IG1 Relay Freezing

TSB REVISION NOTICE

July 21, 2009 Rev2:

Figure 1.

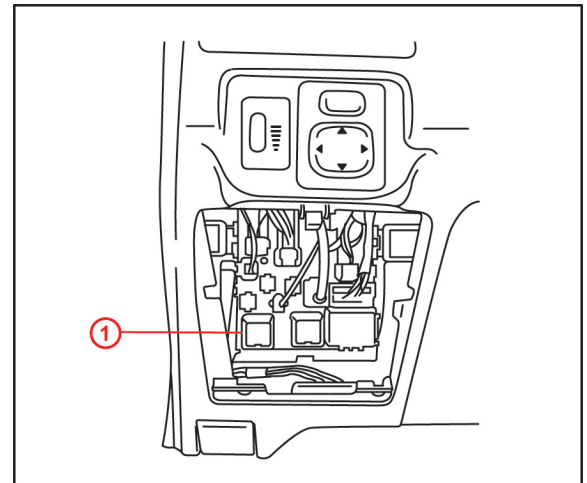
1. Locate the instrument panel junction block No. 1 in the Instrument Panel (as shown in Figure 1).
2. Remove the relay and verify the part number located on the side of the relay.
 - A. If the part number is NOT 90987-02031, then replace the relay with the countermeasure relay.
 - B. If the part number is 90987-02031, then diagnose the specific conditions reported by the customer following the Repair Manual.
